APPLICATION TO THE ZONING BOARD OF ADJUSTMENT

Denial Memorandum

Applicant: Matt and Amanda Lukof

Address: 35 Wardell Avenue, Rumson, New Jersey 07760

> ZONING / SITE PLAN

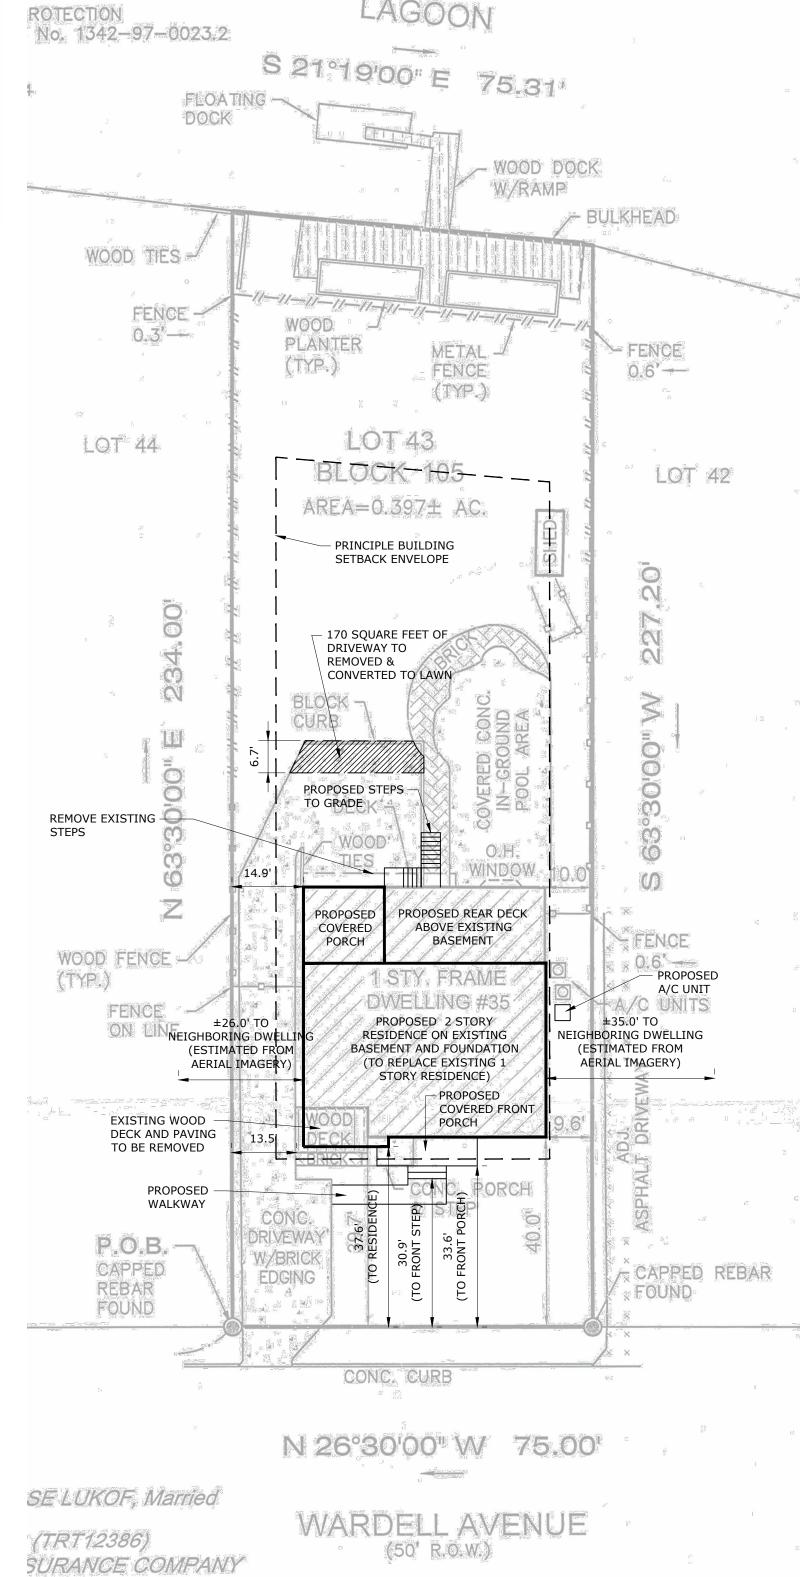
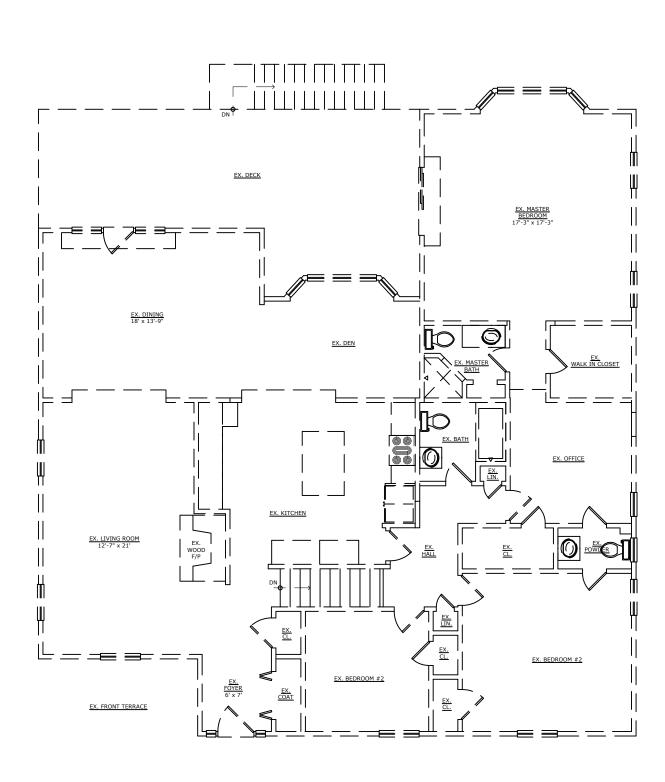
- Add the building envelope on proposed site plan.
- Correct the existing and proposed Front Yard Setback in the Zoning Chart.
- Correct the existing stories to 1.5 in the Zoning Chart.
